# UNITED STATES PATENT AND TRADEMARK OFFICE

APPLICATION NO.	FILING DATE	FIRST NAMED INVENTOR	ATTORNEY DOCKET NO.	CONFIRMATION NO.
10/018,284	11/08/2001	Jan Folkesson	WAL-0006	8368
23413	7590	03/23/2004	EXAMINER	
CANTOR COLBURN, LLP 55 GRIFFIN ROAD SOUTH BLOOMFIELD, CT 06002			WELCH, GARY L	
			ART UNIT	PAPER NUMBER
			3765

**Office Action Summary**

## **DETAILED ACTION**

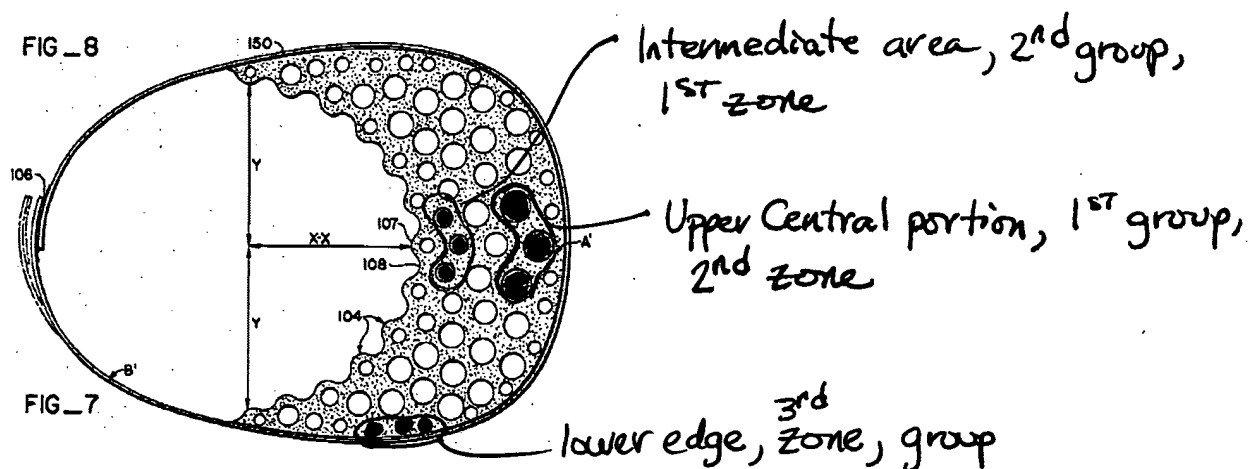
Nordin discloses a safety visor produced by etching metal. The visor has a grid 1 that defines a large number of light-permeating holes 5. The holes 5 are provided across the entire visor.

However, Nordin does not disclose that the holes have different areas, have different configurations and at least two zones have the same area of the holes within the zones and the areas of the holes are different in different zones.

Townsend, Jr. teaches a visor having holes (Figure 7) for providing unobstructed views, minimal wind resistance and air ventilation. The holes have different areas, have different configurations (Col. 7, lines 59-64), at least two zones have

the same area of the holes within the zones and the areas of the holes are different in different zones (see figure below). This configuration enables the wearer to have unobstructed views, minimal wind resistance due to air/wind encountered by the wearer to flow therethrough and ventilation to the wearer's head and face while simultaneously ensuring structural rigidity of the visor due to the placement of the different sized holes about the visor.
